MOUNT PEAKE PROJECT

ADDENDUM TO THE DRAFT ENVIRONMENTAL IMPACT STATEMENT

Wilora, Northern Territory

Animal Plant Mineral Pty Ltd

Figure 2-4: Mount Peake Mine Site Layout

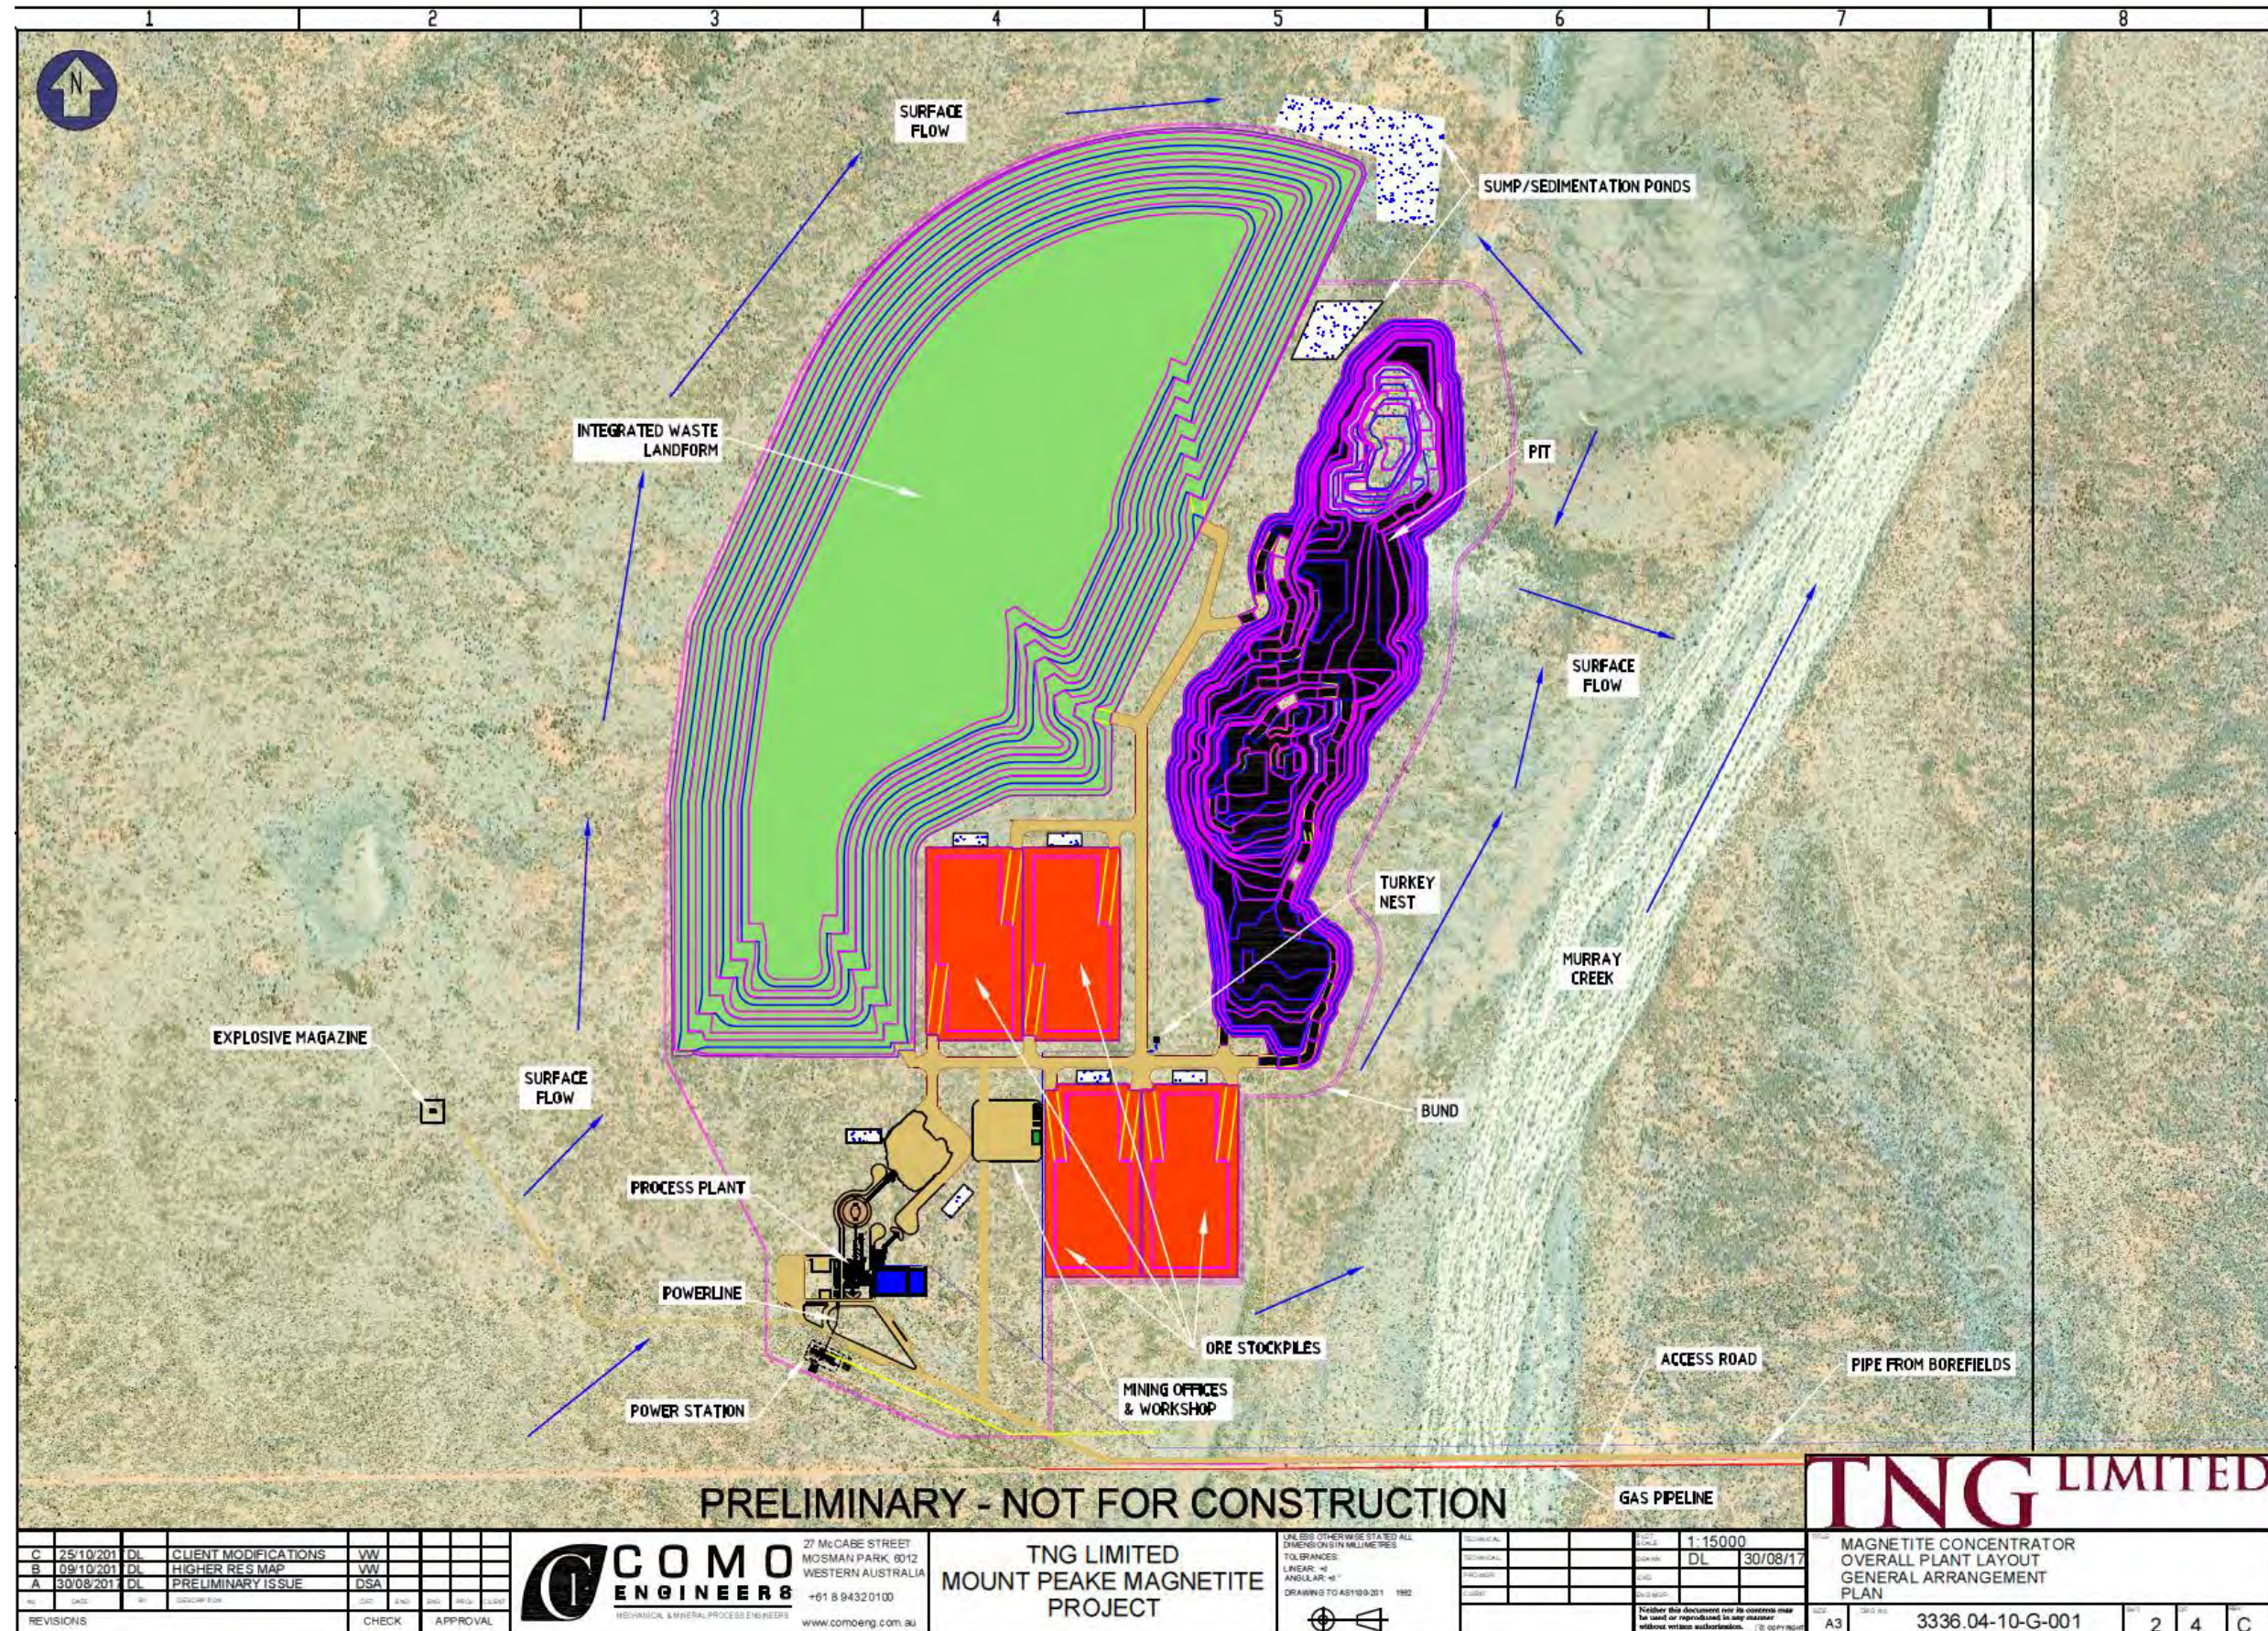
The Draft EIS proposed a 90 ha WRL to accommodate waste rock generated from the Mount Peake Pit. Following revision of Project components, an IWL will now be constructed to contain both waste rock from mining operations and filtered non-magnetic tailings material.

The IWL will have a final footprint of 237 ha, with capacity to store up to 65 Mt of waste and approximately 60 Mt of tailings. Up to 5 Mt of non-acid forming waste from pre-production may be used for Project construction requirements.

Figure 2-4 illustrates the layout of the Mine Site, including the IWL.

Figure 2-5: Site Layout of the Mount Peake Project

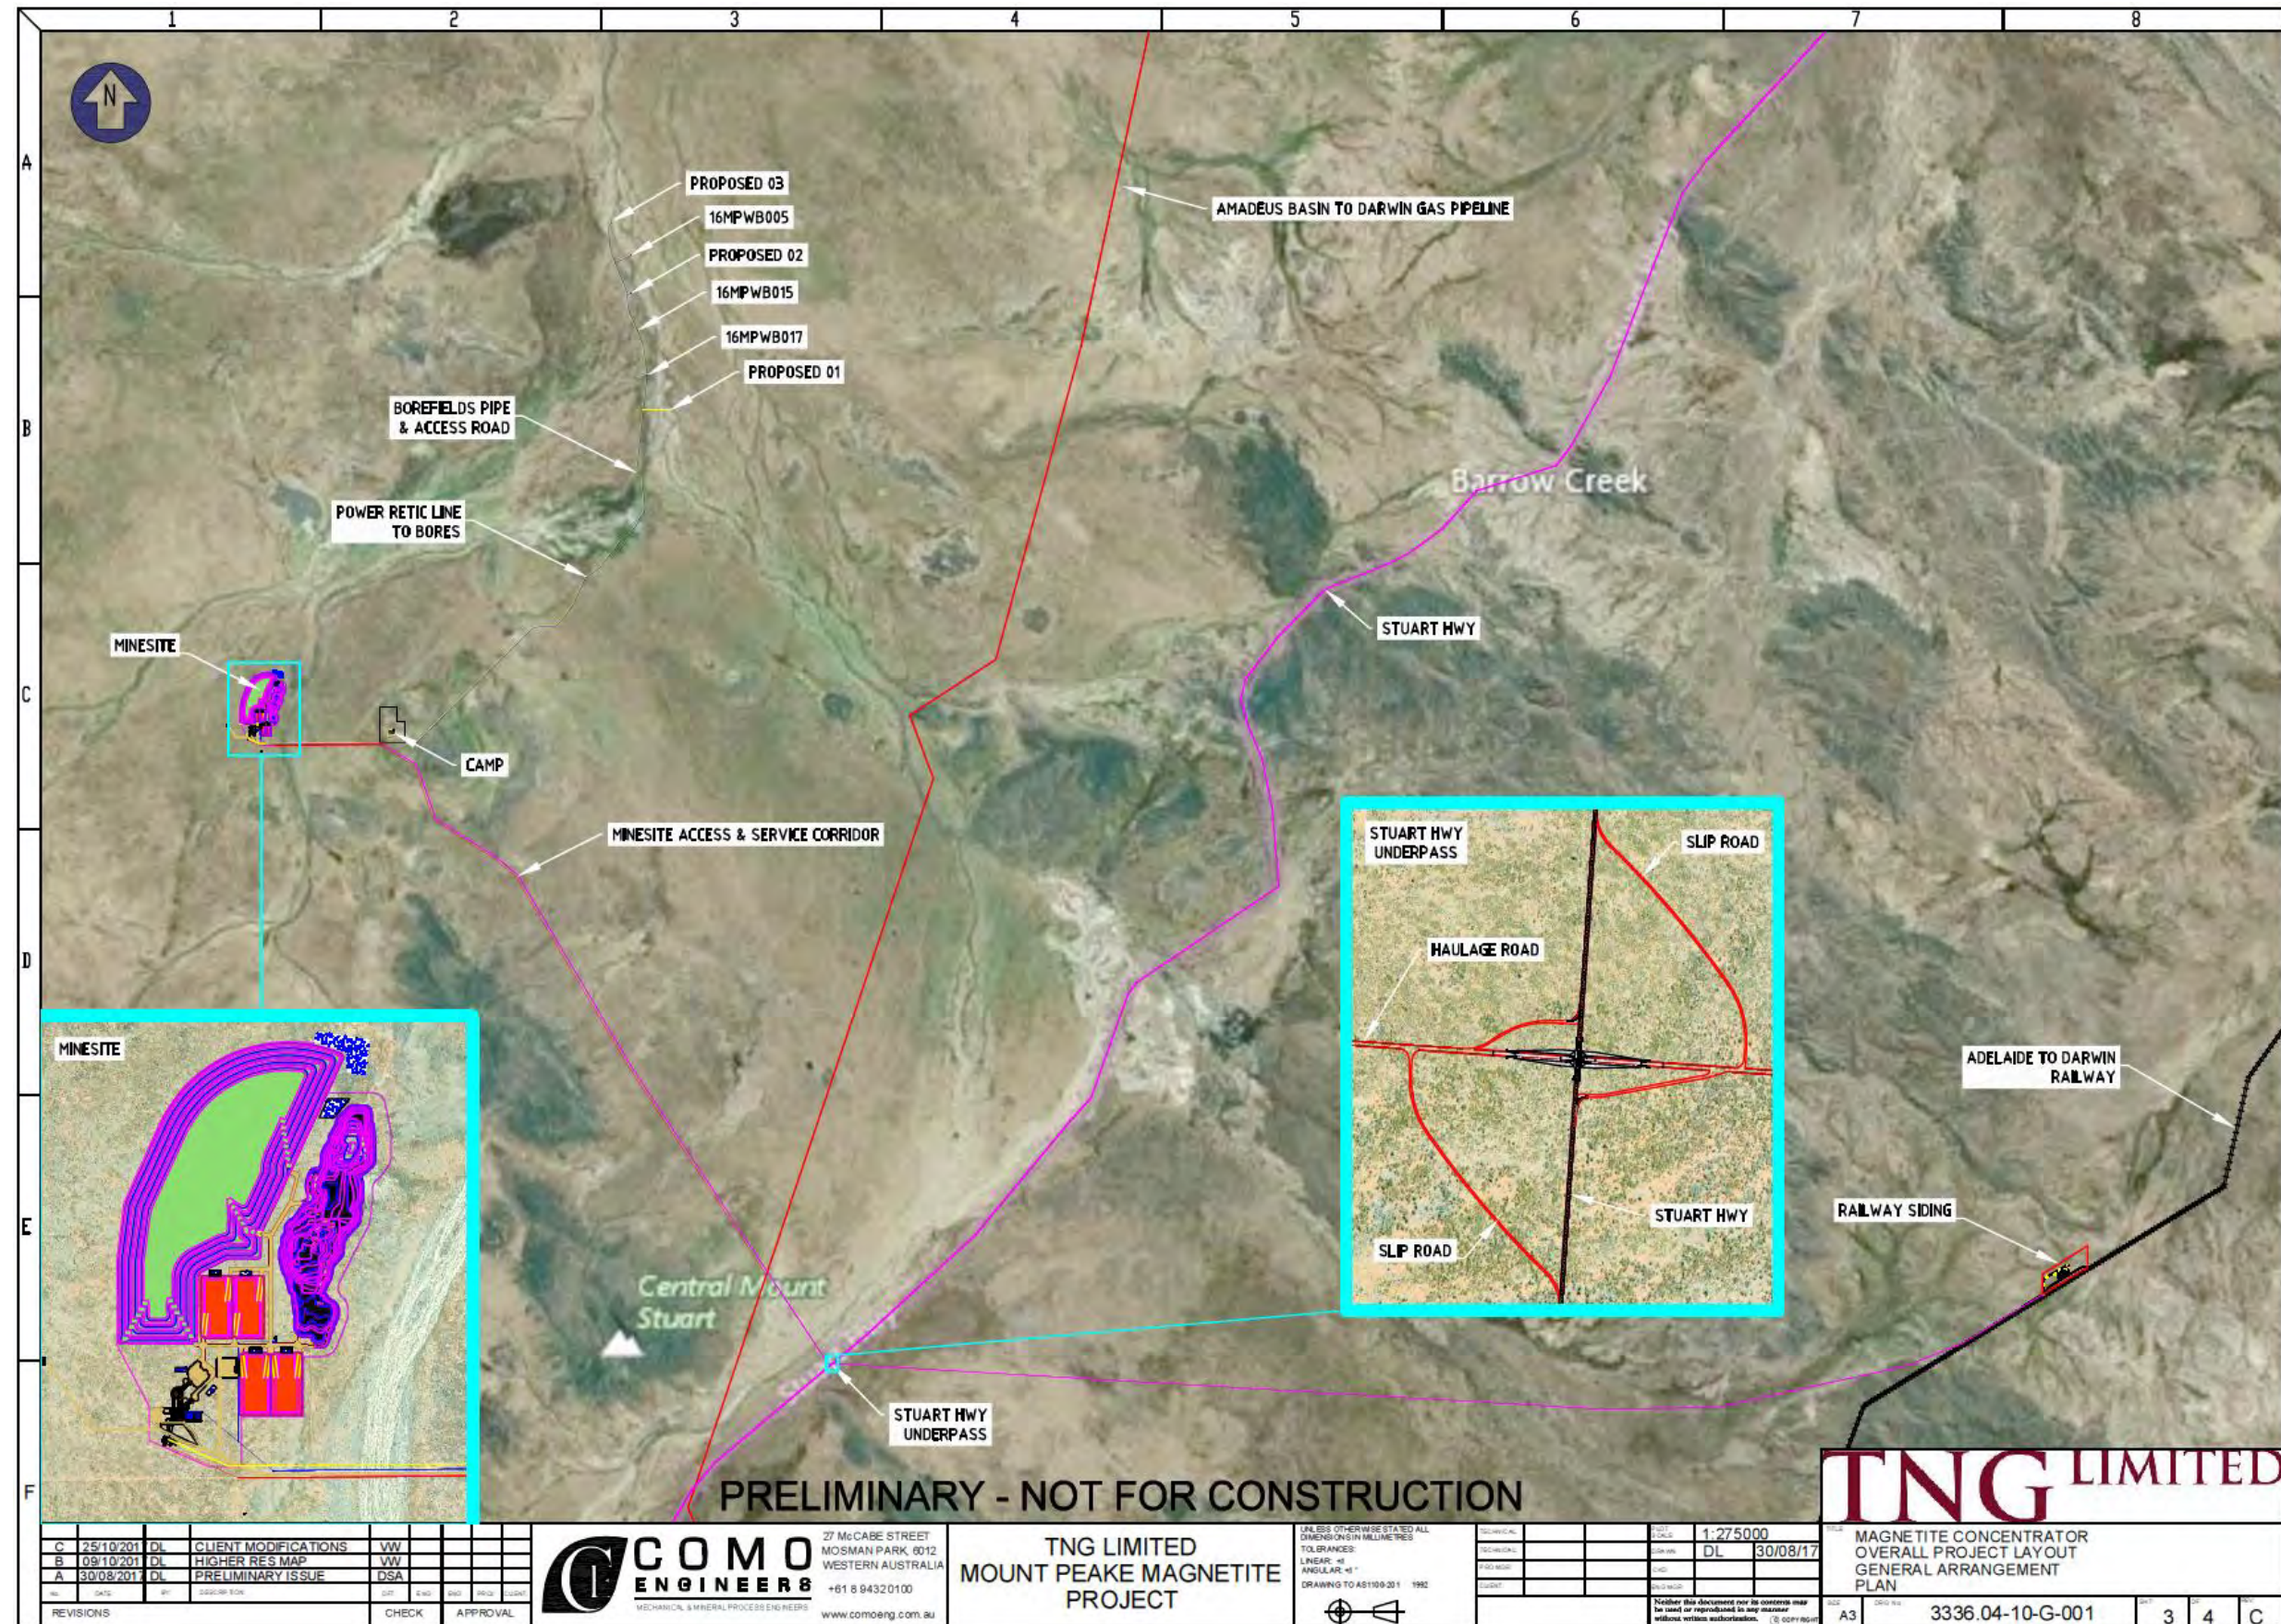
Feature	Description	Area (ha)
Open cut mine	2000m length, 600m width, 125 m depth providing up to 9.6 Mtpa of ore and waste.	77
Integrated Waste Landform	Co-disposal of waste rock and dry-stacked tailings material; landform to have 40m final height, with 10m batter height and 65 Mm ³ capacity.	237
Long-term ore stockpiles	4 x long term ore stockpiles 4 Mt capacity.	47
Mine facilities	Including ROM pad, process plant, mine offices and workshops, fuel storage facility, water treatment plant, power station, magazines, weighbridge and site roads. Producing approximately 1.8 Mtpa of magnetite concentrate.	71
Accommodation village	To accommodate 130 personnel expanding to 175 personnel in year 5, including sewage treatment plant.	6
Haul/access Road	100 km haulage route between mine site and Adnera load-out facility, including access from Stuart Highway for small vehicles and supplies. Two 5 m traffic lands with two 0.5 m shoulders.	234

Figure 2-5 provides a site layout for the Mount Peake Project.

Figure 3-2: Sequence of open pit mining at Mount Peake Project

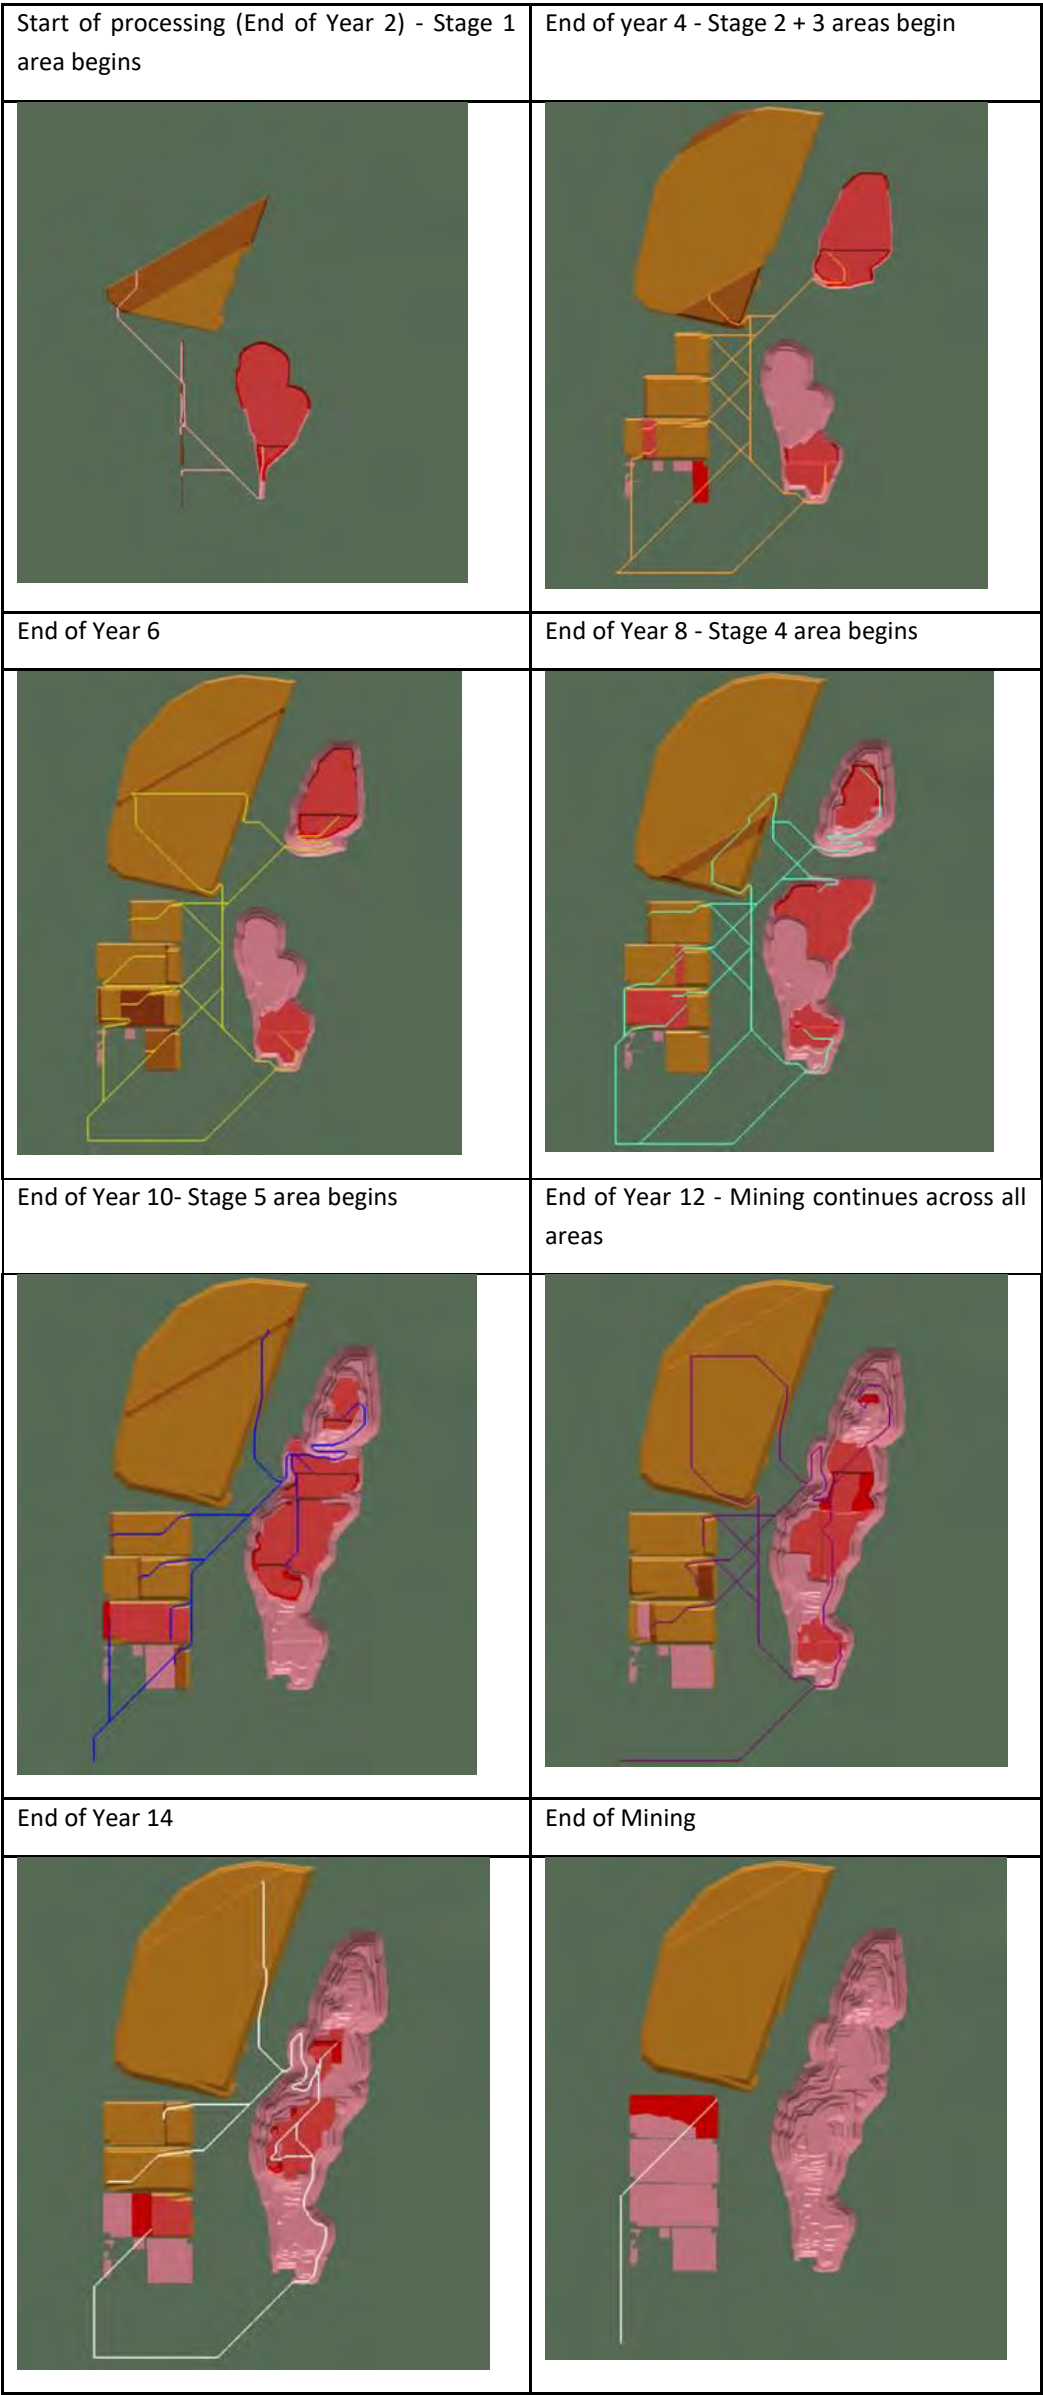
*Diagram reflects the proposed mining sequence, however the waste rock dumping sequence has now altered due to Project revision to store tailings within the Integrated Waste Landform, thereby increasing IWL footprint.
